IFB No: 22-MABC01 DUE DATE: May 16, 2022

#### **ADDENDUM No. 1**

## CONSTRUCTION of the Monument Academy Recirculation Project

DATE OF ADDENDUM: May 9, 2022

- 1. Bull Nose Detail
- 2. Minimum Materials Testing Requirements

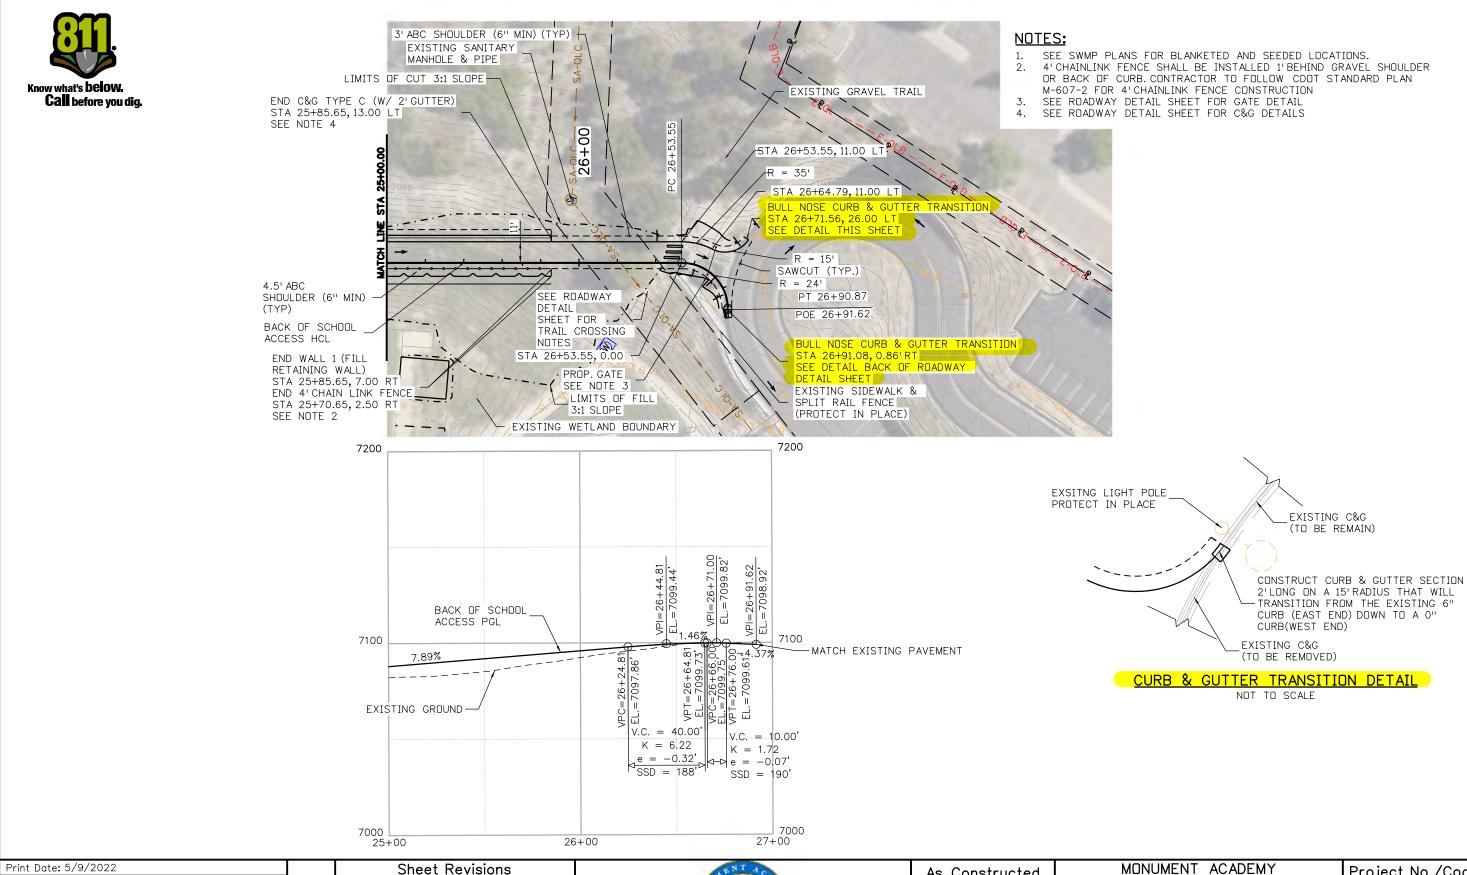
3. Is there a detail available for item 35 bull nose curb and gutter?

MABC response: See attached for the detail for the Bull Nose Curb.
